Dear Reviewers:

Thank you for your kind revisions and comments, in the revised version of the manuscript, we took into account all the comments of the reviewers and made the manuscript corrections as they suggested. In the revision submission, we provided two documents, one marked-up manuscript version (Xiaoyue_Zhou_REV.doc) showing the changes made, and the other final version of the manuscript (Xiaoyue_Zhou_DEF.doc). Thanks to the reviewers' kind suggestions. In the manuscript, the organizational structure of the paper is adjusted in detail, especially in the introduction part, which explains the advantages and disadvantages of seismological methods and traditional hydrological stations and remote sensing methods for monitoring river processes, and adds references for theoretical support, and describes the experimental settings in more detail, and draws a table of the placement of seismic instruments in the experimental process, which is composed of four experiments in four sections of a river, in order to explore the application of seismological methods in monitoring river processes. In this study, an empirical model was constructed based on the research results of previous sch

Figure 2. Monthly precipitation at the experiment site

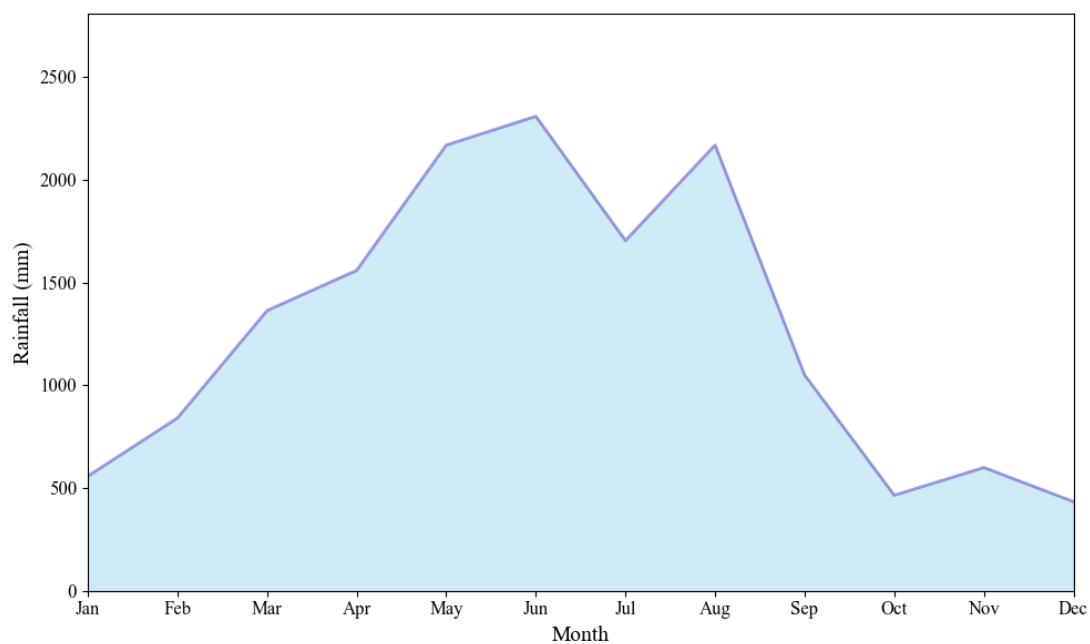
I. 97-98: Can you provide some statistics on the discharge of the Jiuqu river (annual mean, variability, discharge during the experiments, etc.). Also, why is the discharge different between the different sections (e.g. tributary input?). If assuming mass conservation, the discharge is constant between the different sections, and it is its partitioning between width, depth and flow velocity that varies.

Response: Thank you for this suggestion. Data on the study of river flow have been added to the manuscript, and the specific changes are presented in the manuscript. The discharge different between the different sections may be due to the tributaries. The average annual precipitation in the study area was plotted.
